MONTGOMERY COLLEGE - OFFICE OF PROCUREMENT
MACKLIN TOWER MBI FINANCE LAB SUITE 100, ROCKVILLE CAMPUS
RFP NO.: 620-011
RFP CLOSING DATE AND TIME: APRIL 7, 2020 @ 3:00 PM

ADDENDUM #1
Issued: March 27, 2020

Project:	MC RV MT MBI FINANCE LAB SUITE 100 RENOVATIONS	Date:	03/25/2020
		Reference:	
Title:	Addendum #1 Drawing Narrative	BKM Project No:	19106.01

SHEET TITLE:
PLANS & ELEVATION

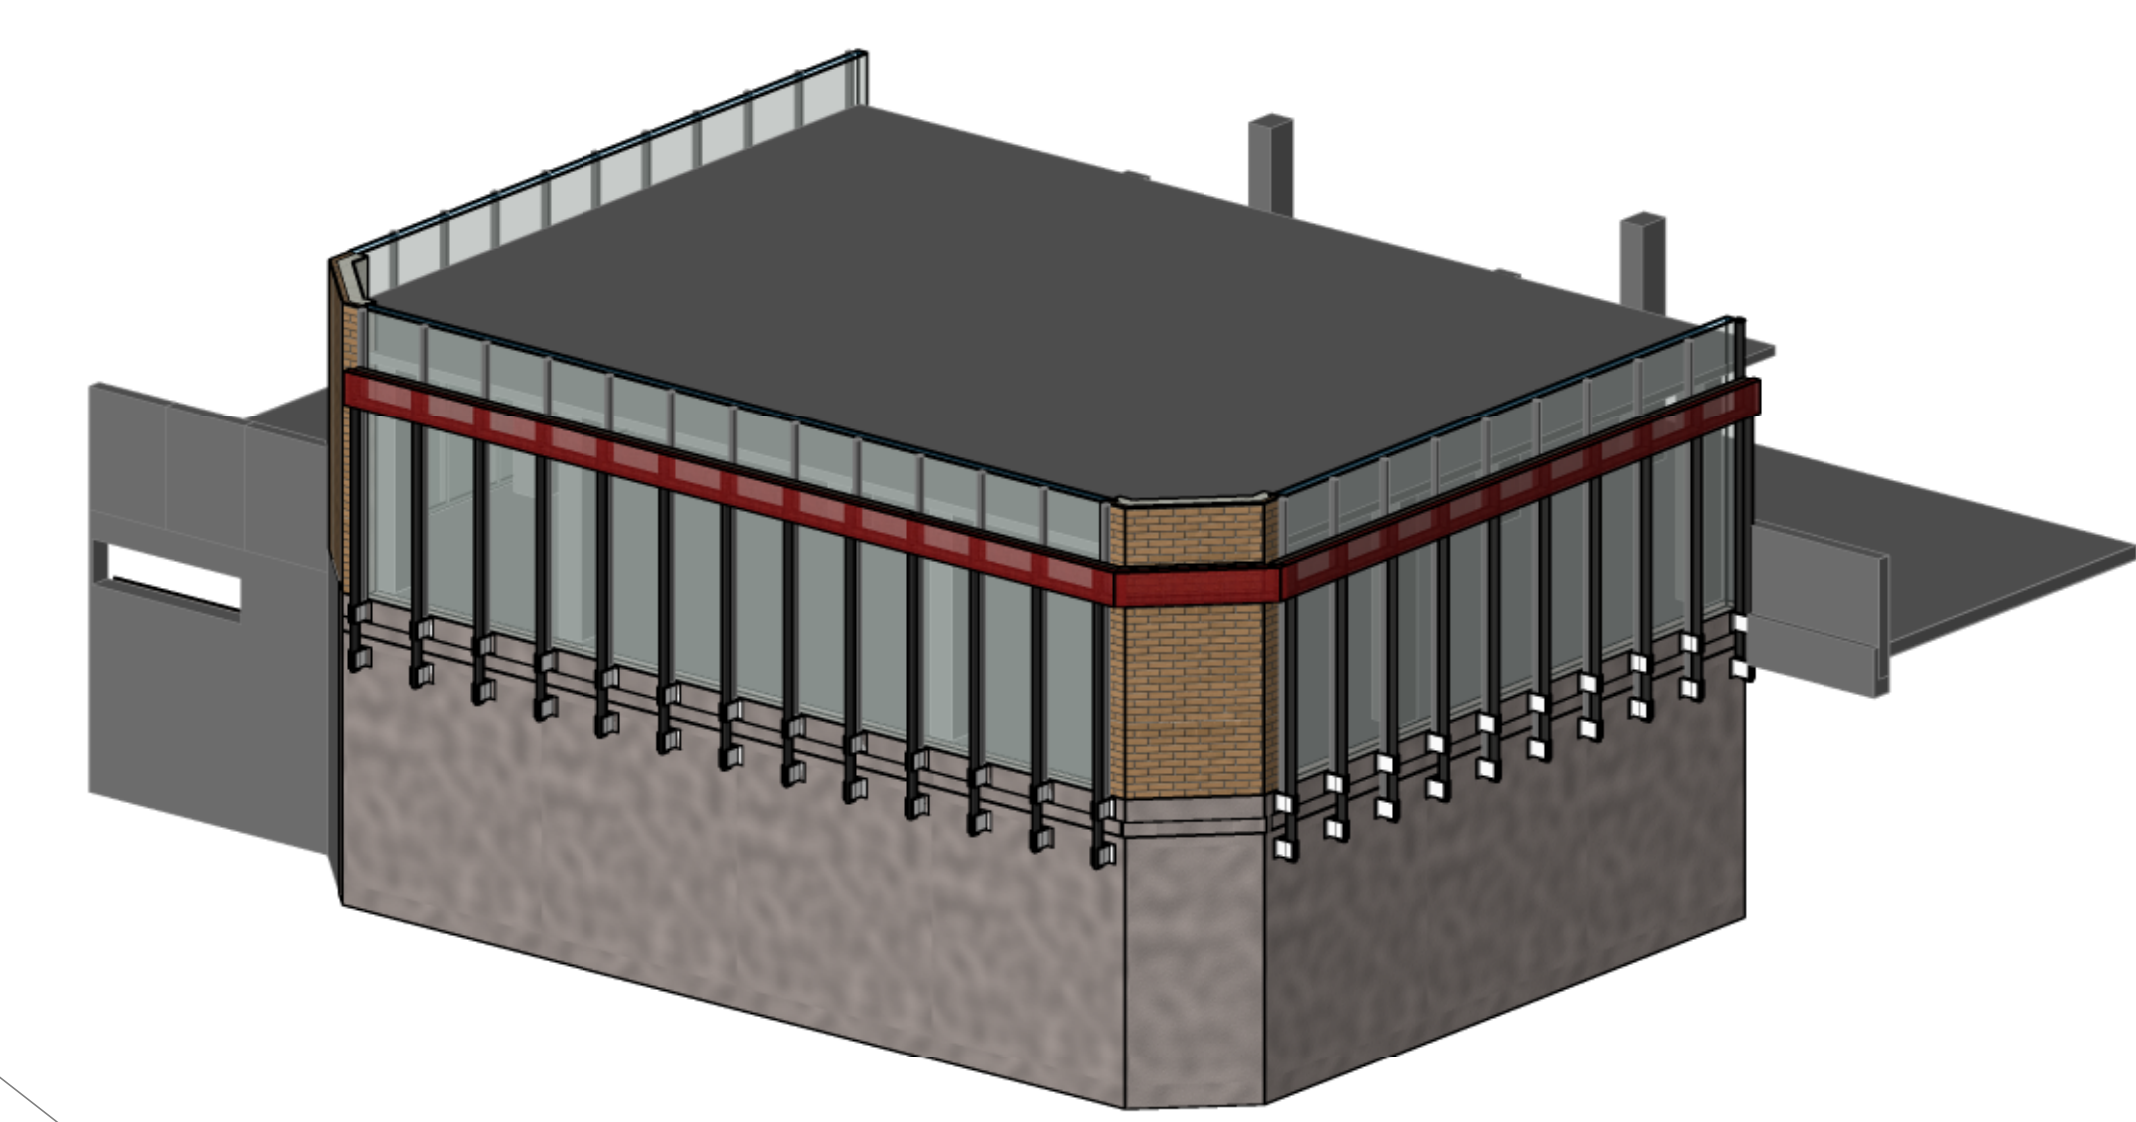
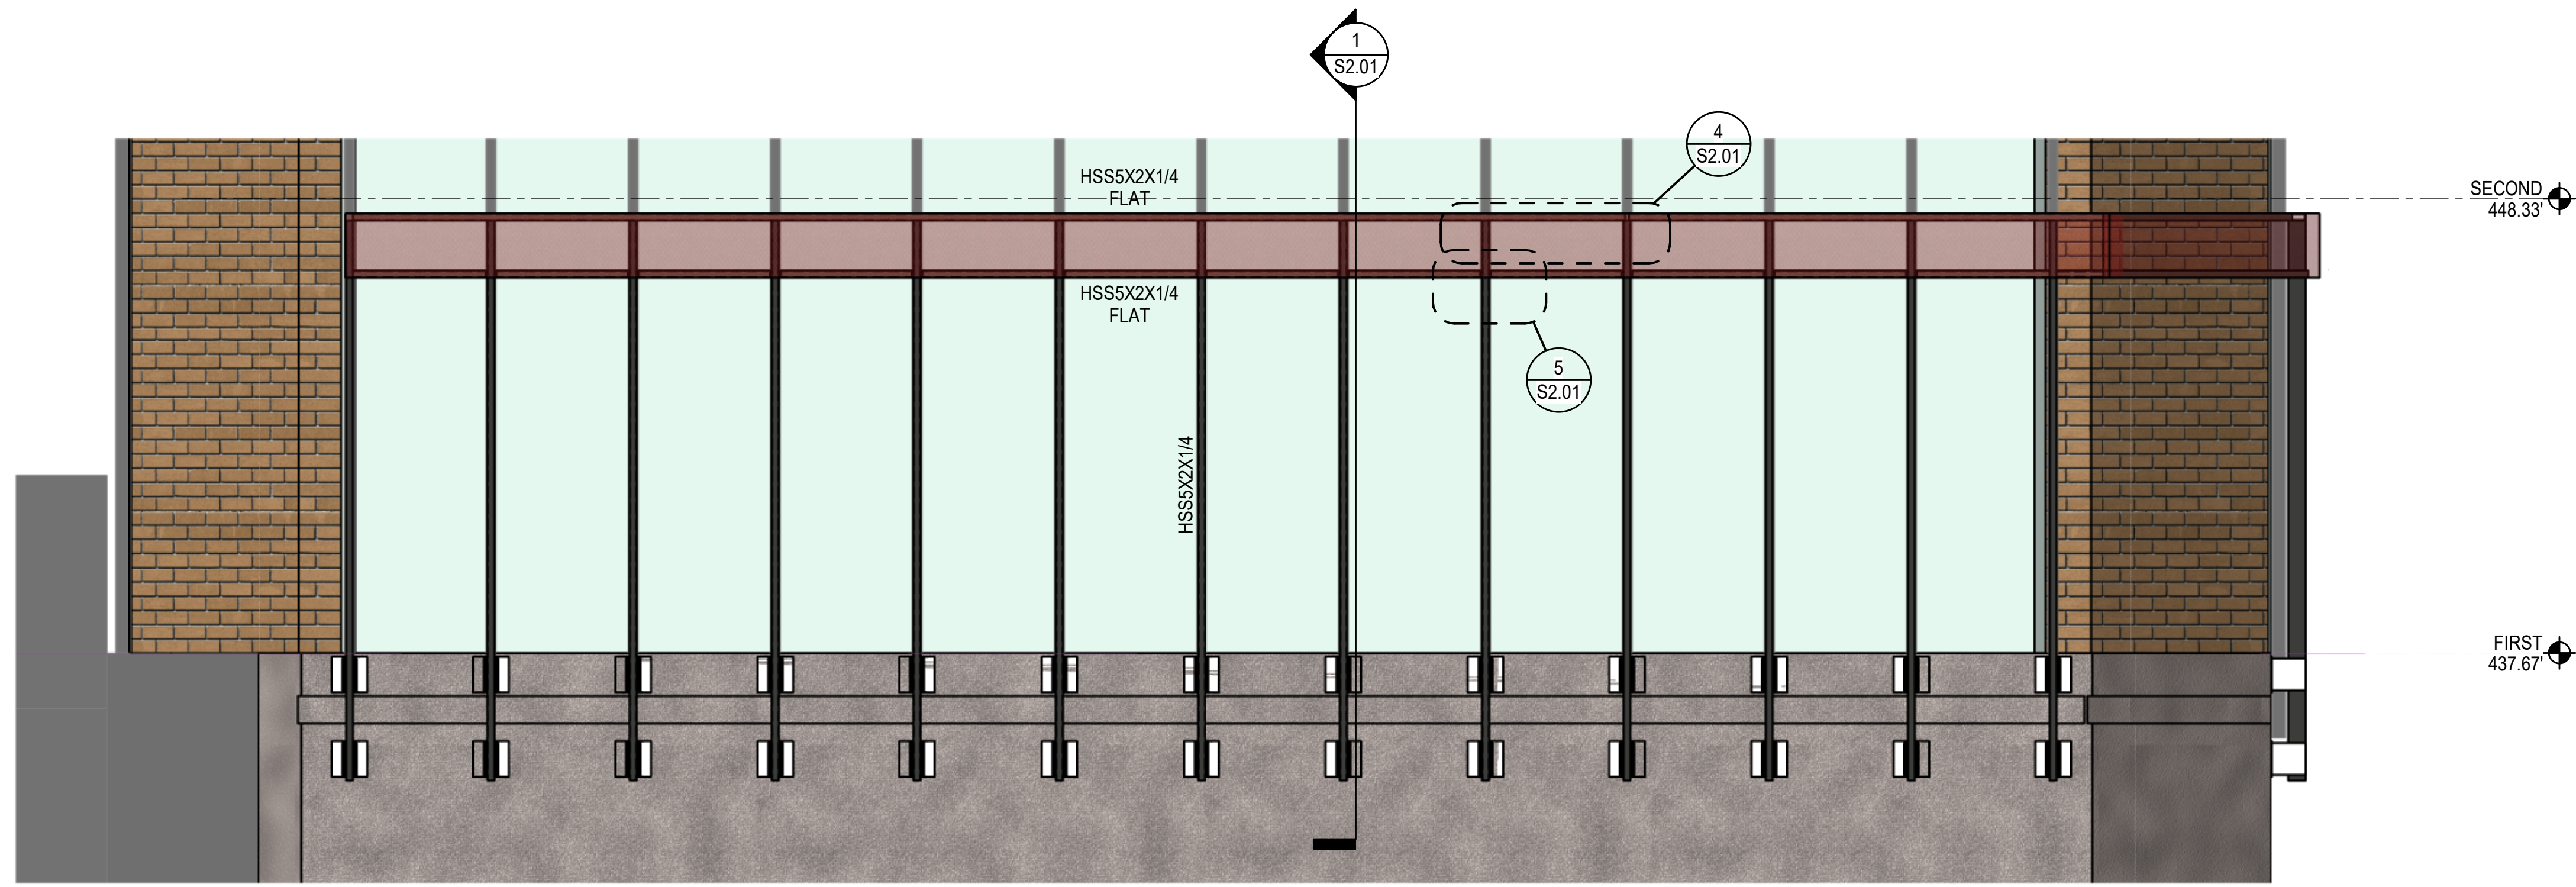
S1.01 – Plans and Elevations

1 WALL OPENING REINFORCING DETAIL
 1" = 1'-0"

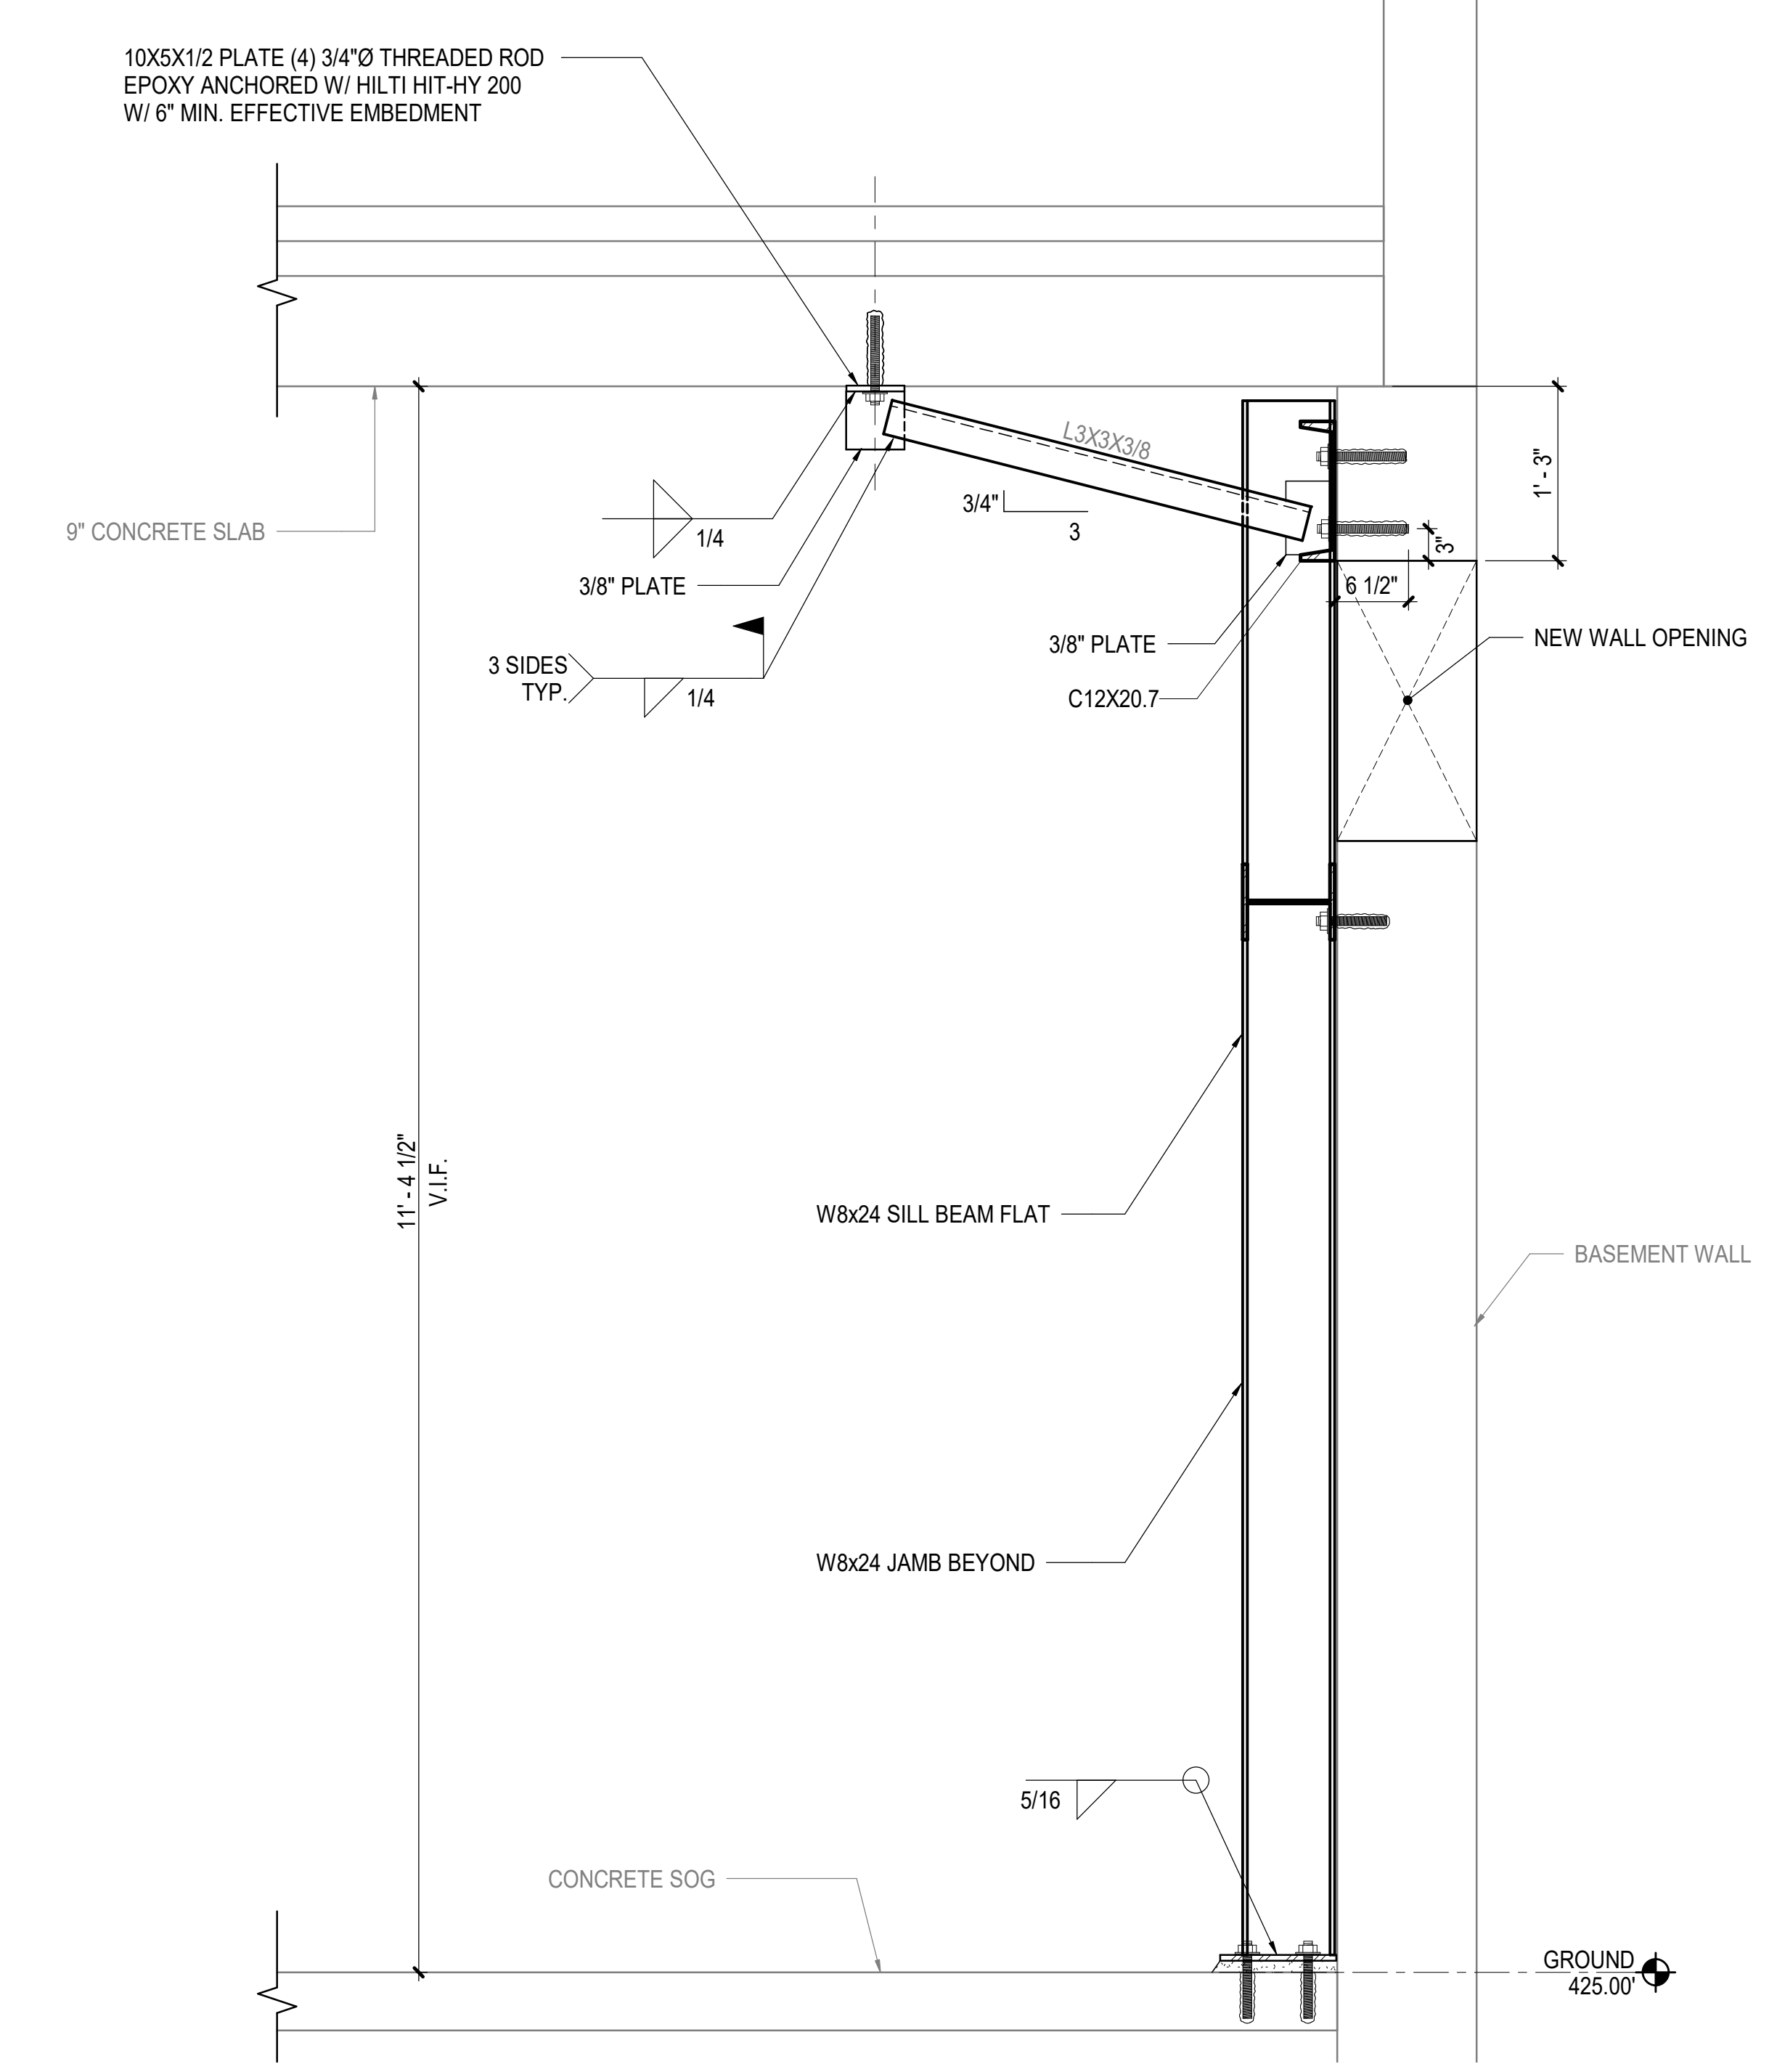
- Wall opening detail has been revised.

SHEET TITLE: GROUND FLOOR PLAN

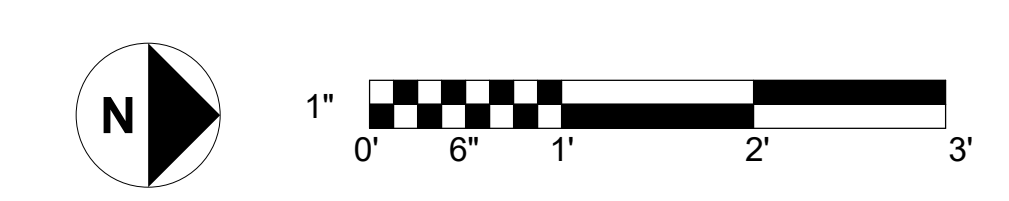
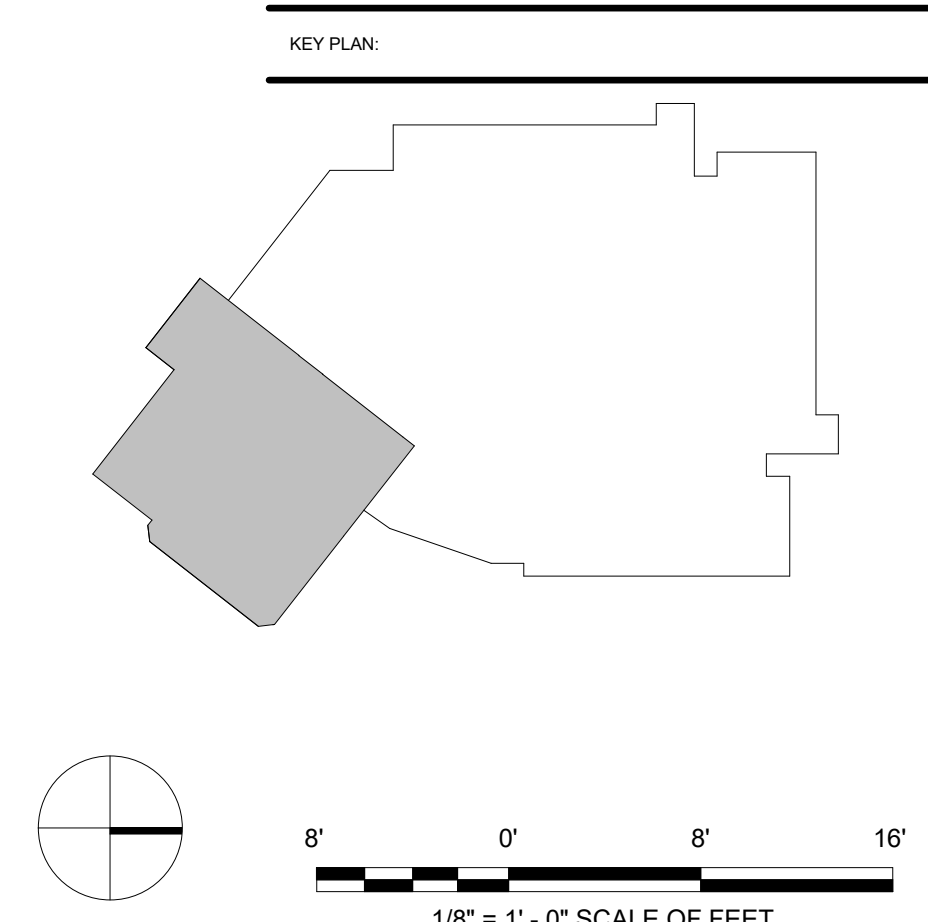
A1.01 – Ground Floor Plan

- Wall sleeve and waterproofing notes added for new penetrations.

PROVIDE WALL SLEEVE AT NEW PENETRATION. PROVIDE WATERPROOF SEAL AT NEW PENETRATION - SEE STRUCTURAL DRAWINGS FOR LOCATION.

SHEET TITLE: FIRST FLOOR RCP

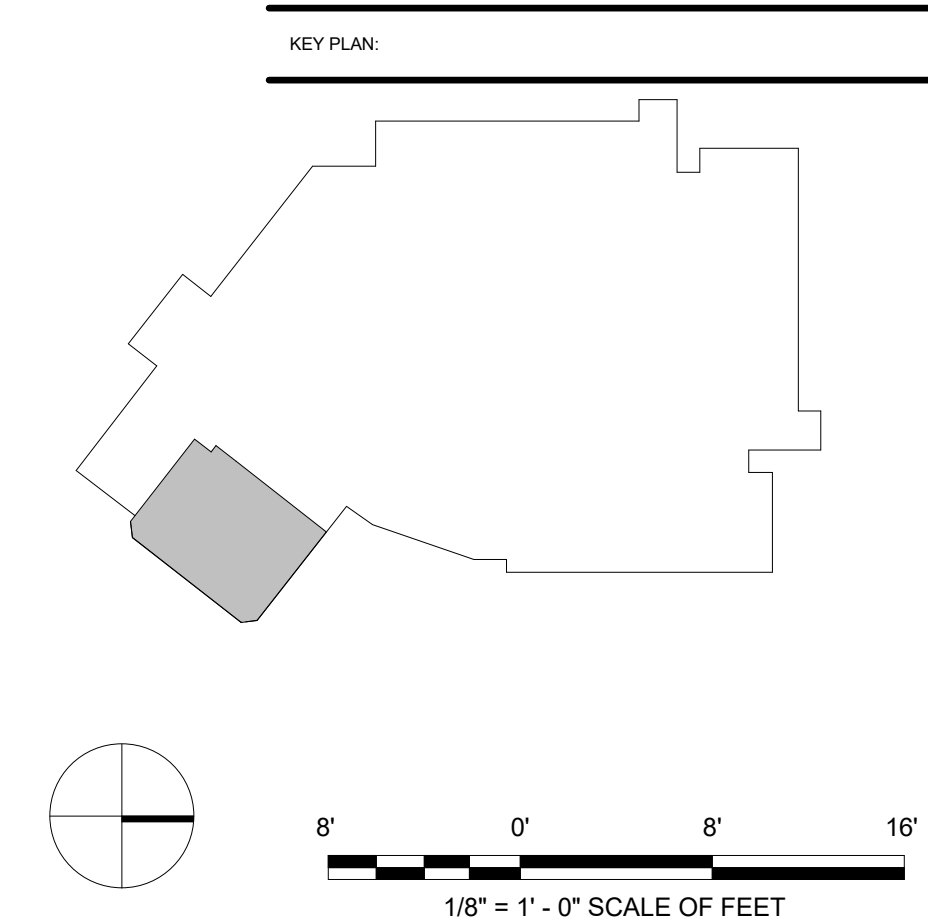
A1.12 – First Floor Reflected Ceiling Plan

- Classroom ceiling system has been modified to a cloud ceiling system.
